THE BRIDGES AT LAKE PARC

RE: DEC ID No. 3-3340-00306/00001
Bridges at Lake Parc
Town of Monroe, Orange County
**Notice of No Jurisdiction – Article 15 Protection of Water Dam Safety &
Article 15 Protection of Waters Stream Disturbance**

SUBJECT: Permit Application Number NAN-2019-01188-WOR
by WC Lincoln Corp

TITLE
 JOIN APPLICATION FOR PERMIT SET

TITLE: LAYOUT AND GRADING PLAN
 (1 OF 3)

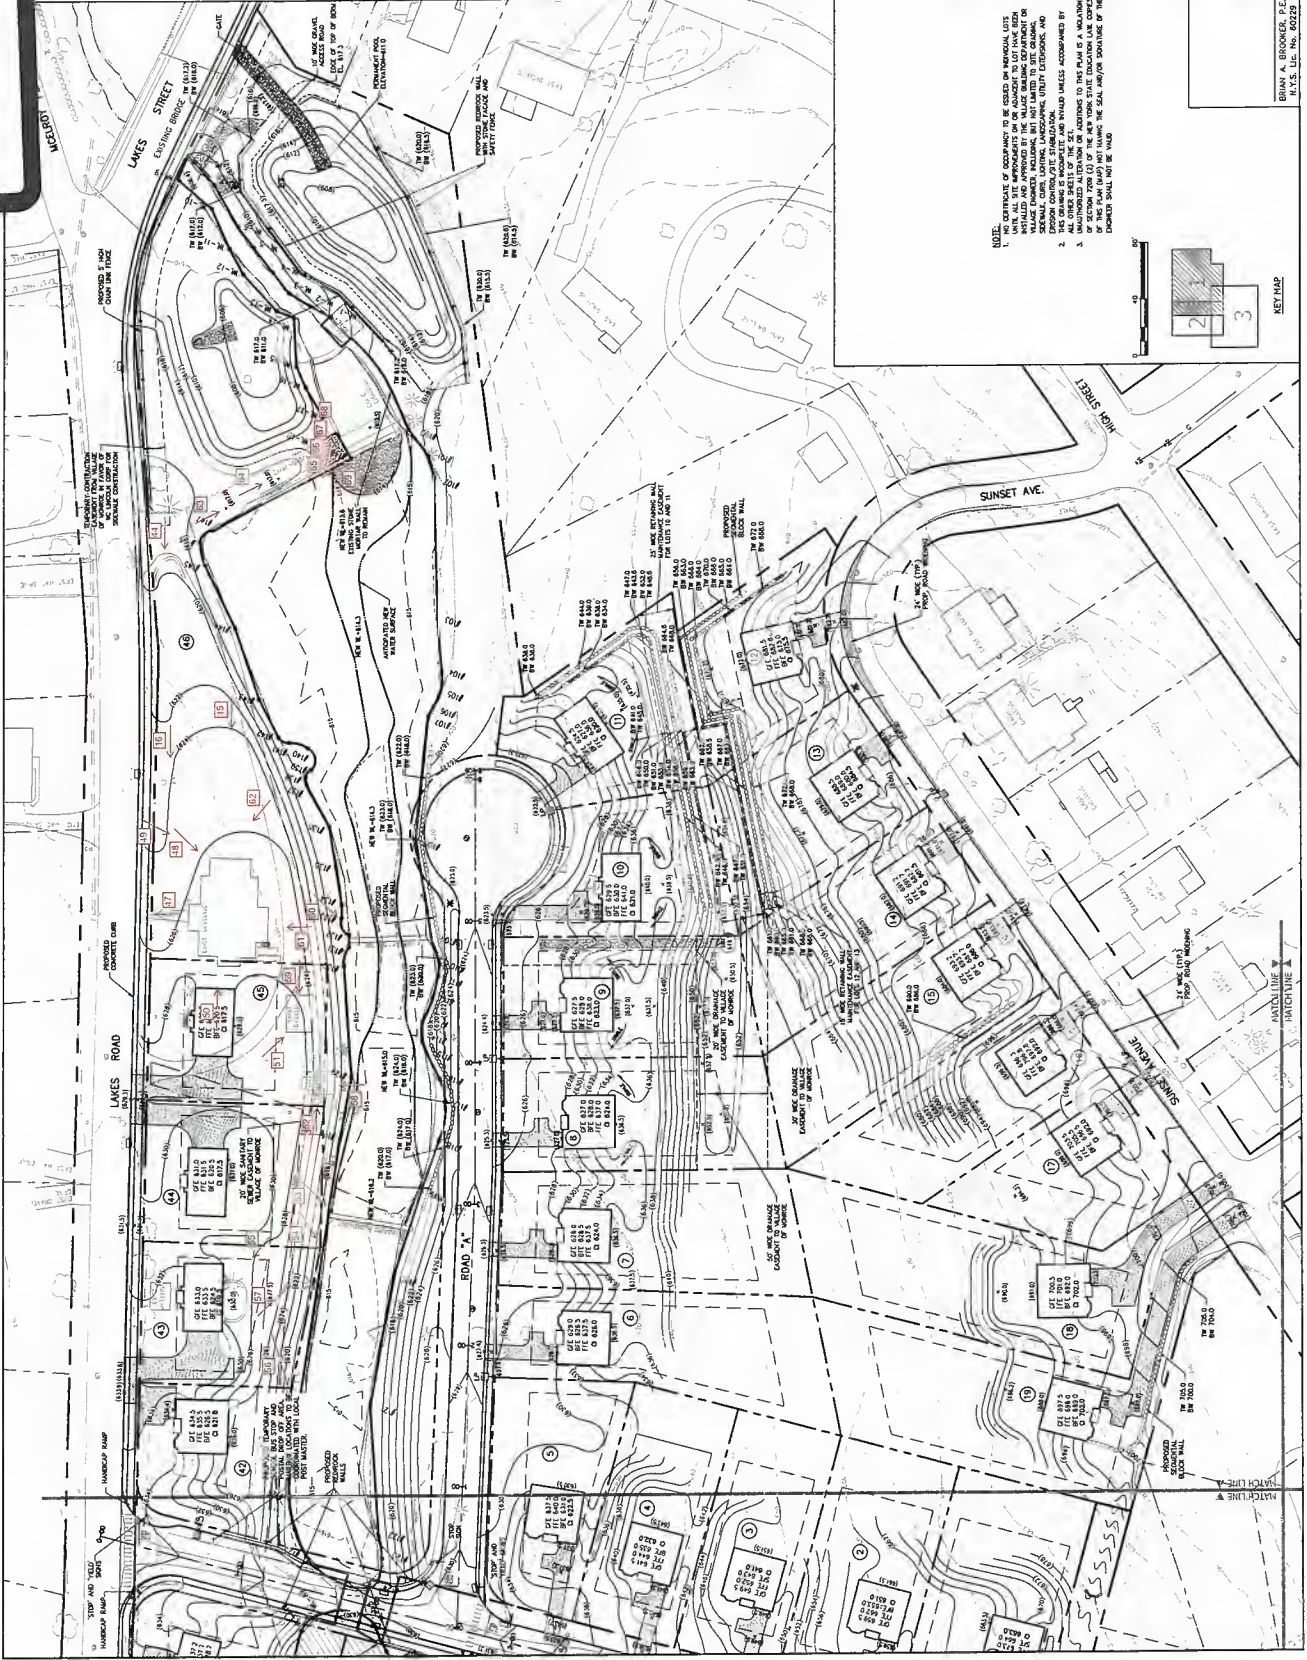
- The submitted plan drawings titled "The Bridges at Lake Parc", sheets 1 through 4 dated 11/16/2017, prepared and sealed by Brian Brooker of Brooker Engineering, PLLC, contains a table with Jurisdictional Water Calculations (Drawing No. 1). These calculations are not consistent with the calculations provided in the written narrative provided for Question 9. Project Description and Purpose. The numbers that are referenced in the written description cite calculations from the issued Nationwide Permit, and these do not appear consistent with the calculations provided on the table. Please clarify the acreage of disturbance and mitigation.

- The submitted plans reference the Wetland Mitigation Plan prepared by Robert G. Torgersen, dated 9/14/2015. Please submit the referenced plan.
- Sediment and Erosion Controls are not shown on the plans. Please provide plans that show the proposed sediment and erosion controls. In addition, if the work area is to be isolated, please shown these measures as well.
